Silicon identification

This errata sheet applies to the M95256-R and M95256-DF, which are 256 Kbit serial SPI bus EEPROMs, and specifically to the devices delivered in 8-bump wafer-level chip-scale packages (WLCSP).

Figure 3. D and E back side view

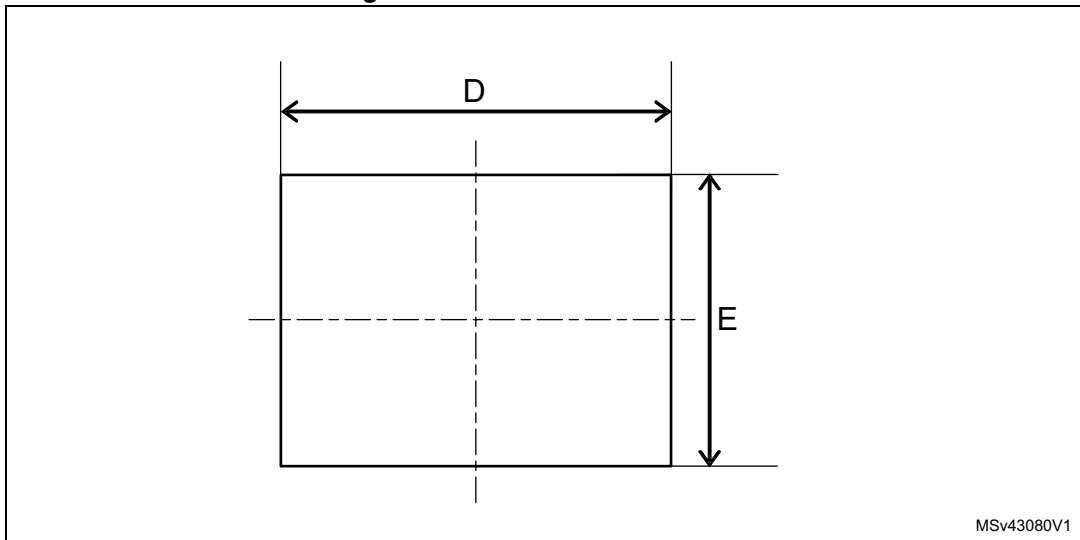
This document refers to the changes in dimensions D and E (see [Figure 3](#)) described in the M95256-R/M95256-DF datasheet, in tables detailing the dimensions of the WLCSP 8-bump package.

D and E values must be modified to correct the following mistake:

- The D and E values in the M95256-R/M95256-DF datasheet correspond to front side view (ball side), instead of back side view (marking side view).
[Table 2](#) and [Table 3](#) report the data for the front and back view, respectively.

Table 3. D and E values corresponding to back side view

Symbol	Millimeters			Inches		
	Min	Typ	Max	Min	Typ	Max
D	-	1.289	1.309	-	0.0507	0.0515
E	-	1.376	1.396	-	0.0542	0.0550

Figure 4. D or E side view

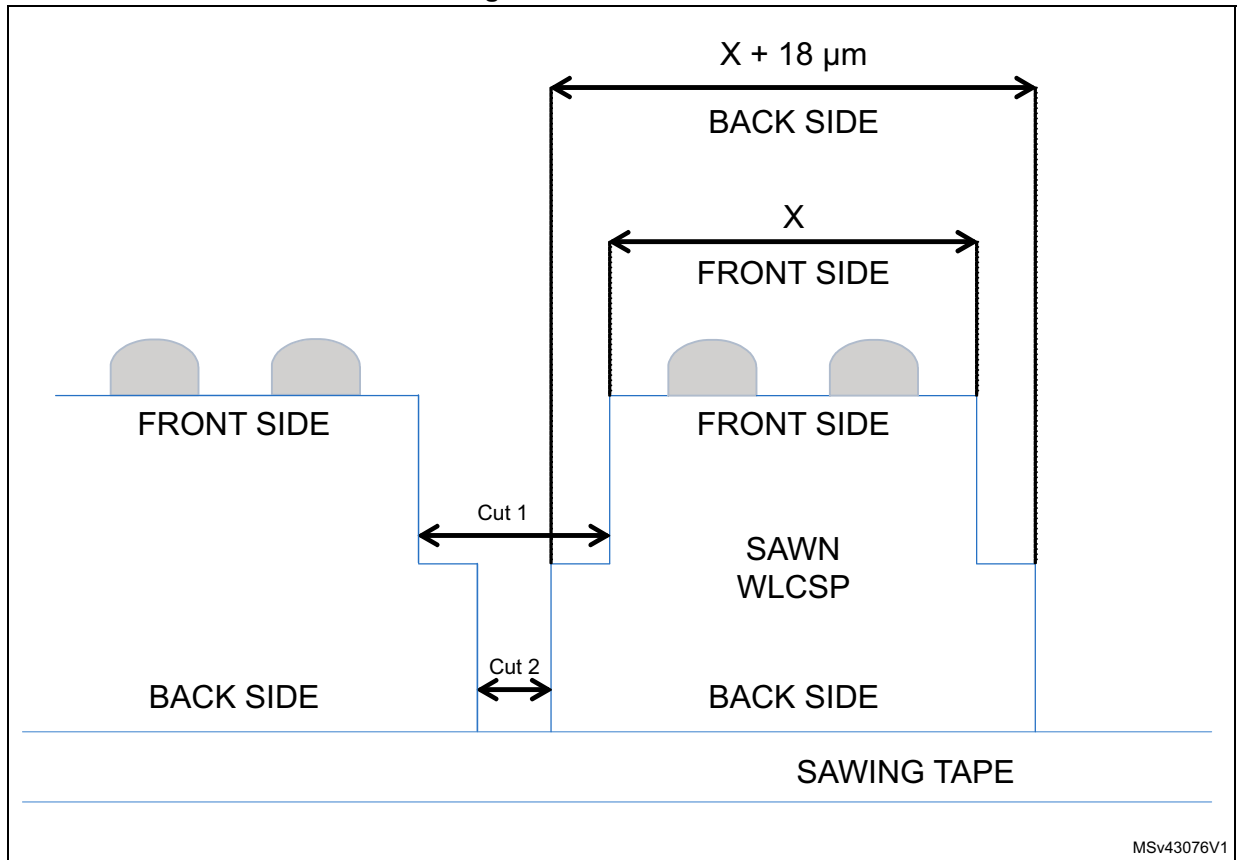
The difference between back side and front side dimension is 18 µm (0.018 mm). This difference is due to the two-step sawing process, where cut 1 and cut 2 are performed with blades having different thicknesses (see [Figure 4](#) in which X represents D or E and it has the same value and tolerance).
